South Texas Project
Units 3 and 4
Docket Nos. 52-012 and 52-013
Revised Response to Request for Additional Information

1. RAI 03.07.01-29, Supplement 2
2. RAI 03.07.02-32, Revision 1

RAI 03.07.01-29, Supplement 2**QUESTION:**

RAI 03.07.02-32, Revision 1**QUESTION:**

Figure 03.07.01-29 S2.1: Isometric View of the Fixed Base SSI Model of UHS/RSW Pump House – Using Original SSI Mesh

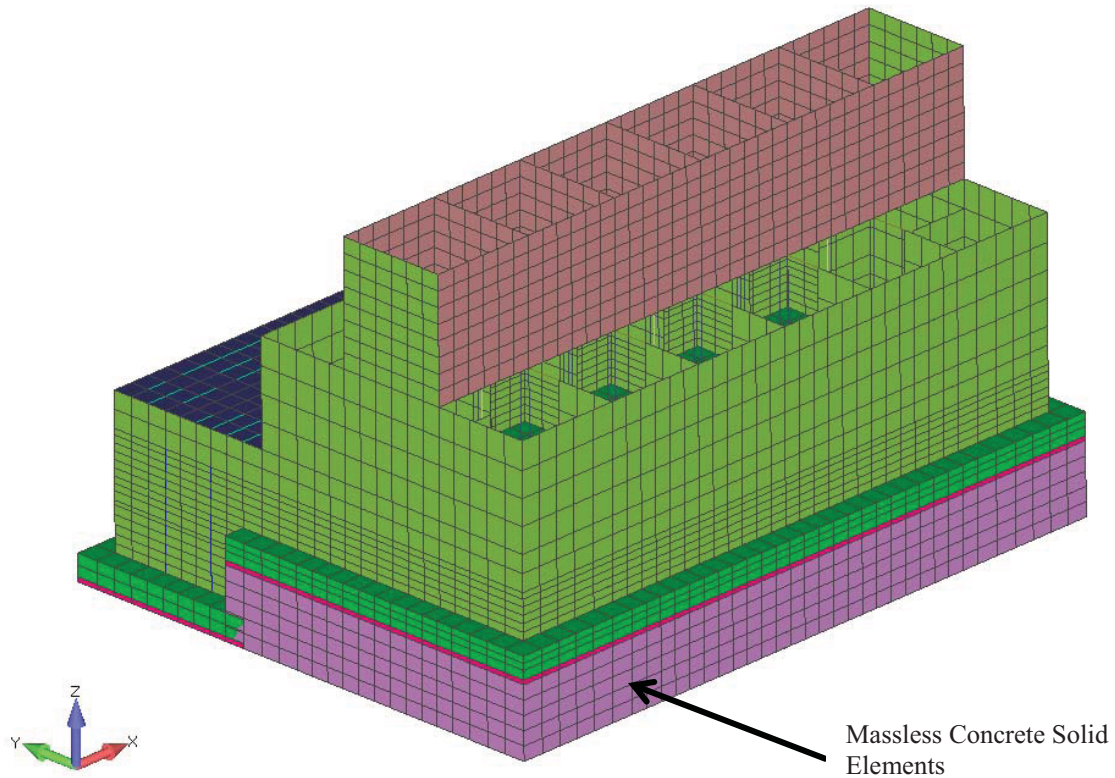
The Defense Nuclear Facilities Safety Board (DNFSB) has identified a technical issue in SASSI that when subtraction method is used to analyze embedded structures, the results may be non-conservative. Because the subtraction method has been used for the STP Units 3&4 SSI/SSSI analyses, NINA is requested to demonstrate the acceptability of the subtraction method and the results, or provide a plan and schedule to ensure that the SSCs are designed to meet the requirements of GDC 2. Therefore, the applicant is requested to address the following:

1. For all STP Units 3&4 Seismic Category I structures, compare the In-Structure Response Spectra (ISRS), structural loads, and any other design response quantities developed by using the subtraction method with those using the direct method or modified subtraction method and evaluate the differences.
2. Demonstrate and justify that the differences identified in Item 1 either have no impact on the design of Seismic Category I structures, or revise the design to address the differences.
3. If the modified subtraction method is used to validate the subtraction method, provide a validation program for the modified subtraction method.
4. Provide FSAR mark-up, if any, in the response to document actions taken to address the resolution of the DNFSB's issues with SASSI versions used by STP Units 3&4 analyses.

- The soil under the UHS basin, from bottom of the UHS basin mudmat down to the bottom of the RSW Pump House mudmat, was replaced with concrete using massless solid elements, see Figure 03.07.01-29 S2.1. In order to avoid fixing the RSW Pump House south wall, as shown in Figure 03.07.01-29 S2.2 the massless concrete elements were not connected to the RSW Pump House south wall.
- The grade elevation was set at the bottom of the RSW Pump House mudmat.
- The soil properties below the grade (i.e. bottom of Pump House) were modified to represent a rigid base through the use of high shear wave velocity of 20000 ft/sec.

The SAP2000 model was identical to the SASSI2000 model that is shown in Figure 03.07.01-29 S2.1 except for the absence of the below grade soil. Nodes identified as the interaction nodes in the SASSI2000 analysis were fixed in the SAP2000 model. The SAP2000 analysis was performed as a linear modal time history analysis utilizing Ritz modal analysis considering 1000 modes. The input ground motions were the site-specific Safe Shutdown Earthquake (SSE), the results from the three seismic excitations were combined using square root of the sum of the squares (SRSS), and only the full basin case was considered.

Figure 3.7- 38a Horizontal (N-S) Control Building Annex Input Motion for III Design (7% Damping)

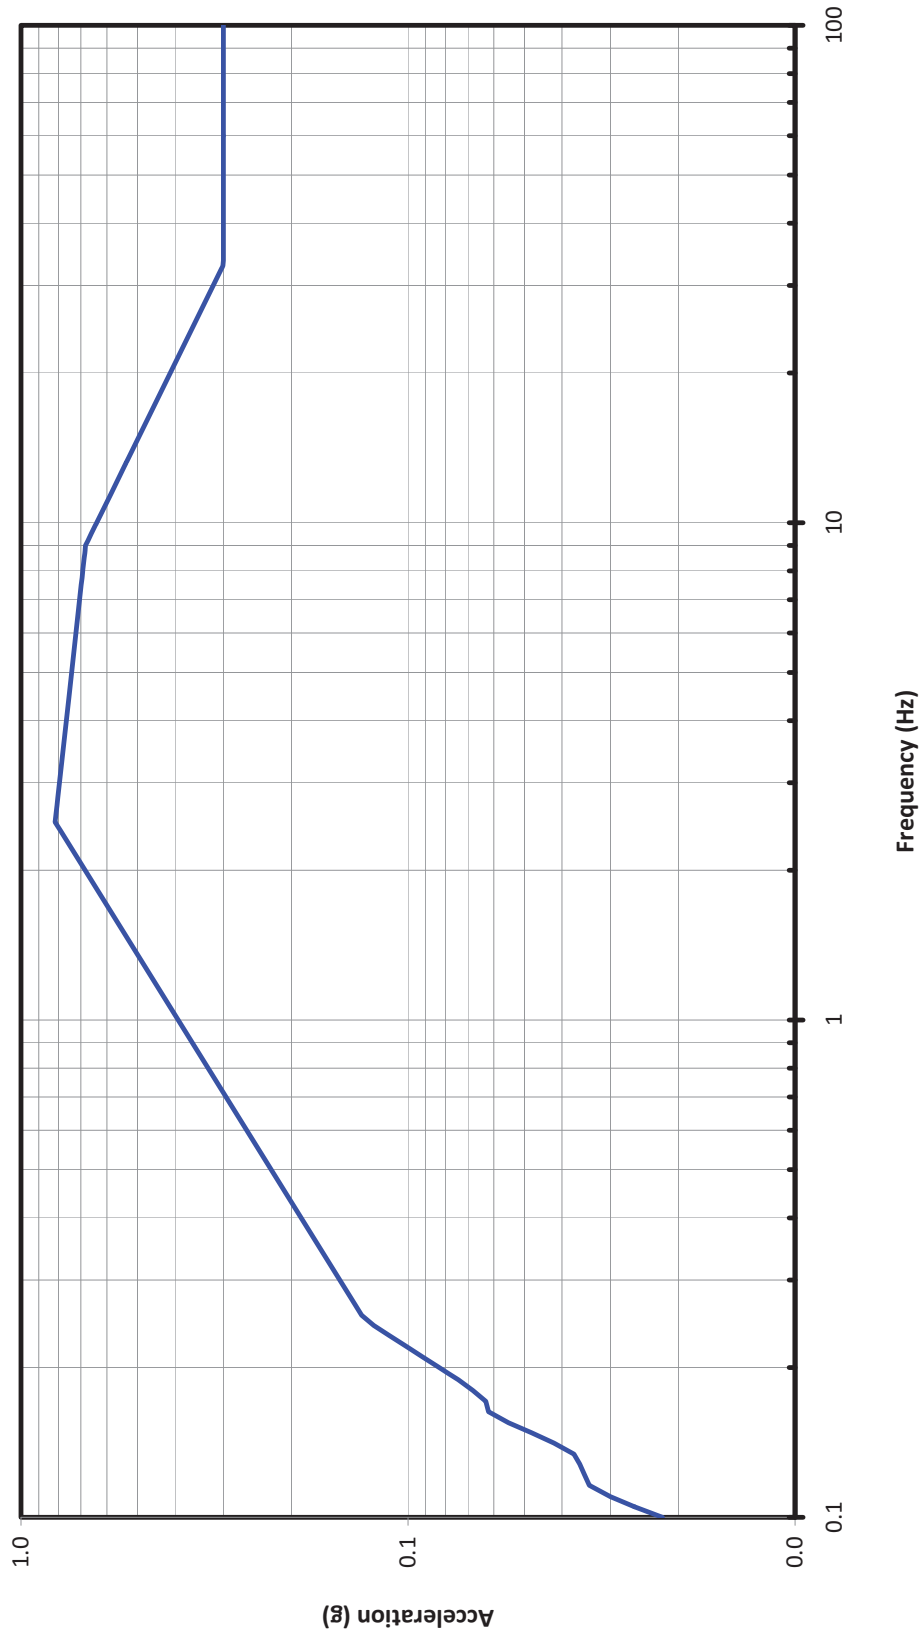
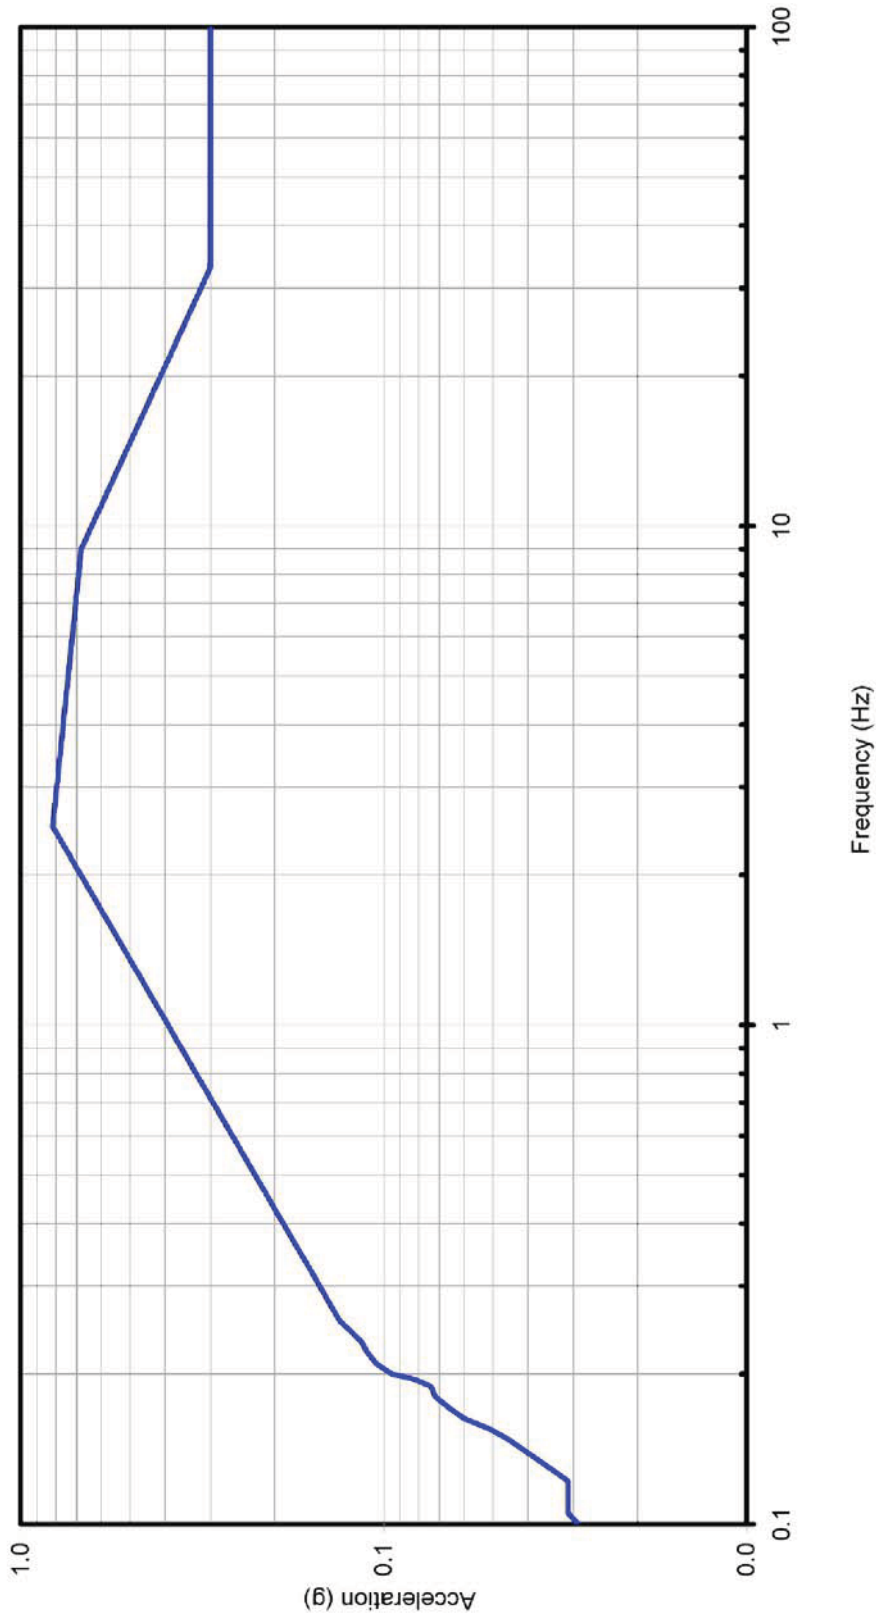
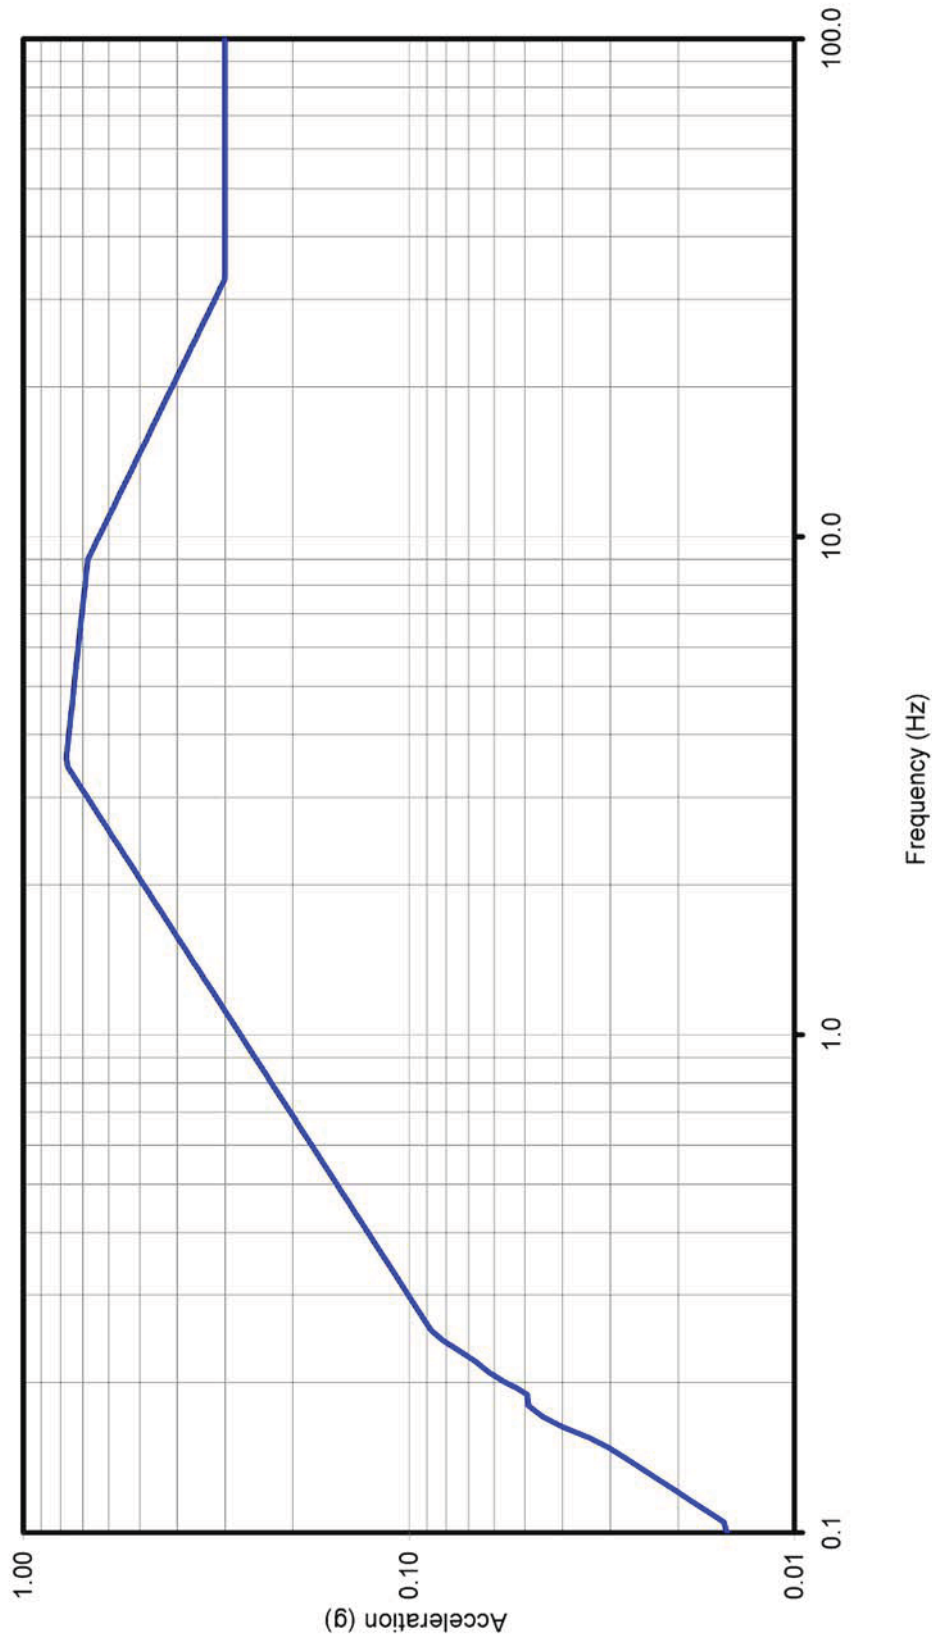
2. Describe in the FSAR the analysis and design of each non-category I structure that can interact with category I structures, to demonstrate that it is analyzed and designed to prevent its failure under SSE conditions in a manner such that the margin of safety of the structure is equivalent to that of seismic category I structures. Also, include site-specific ITAAC for each structure to confirm that the as-built structure is analyzed and designed as described in the FSAR.

For the Control Building Annex (CBA) II/I design, the SSE input at the foundation level (Figures 3.7-38a, 3.7-38b and 3.7-39) is the envelope of 0.3g RG 1.60 response spectra and the induced acceleration response spectra due to site specific SSE that is determined from an SSI analysis which accounts for the impact of the nearby Control Building (CB). In this SSI analysis, five interaction nodes at the depth corresponding to the bottom elevation of the CBA foundation are added to the three dimensional SSI model of the CB. These five interaction nodes correspond to the four corners and the center of the CBA foundation. The average response of these five interaction nodes is enveloped with the 0.3g RG 1.60 spectra to determine the SSE input at the CBA foundation level.
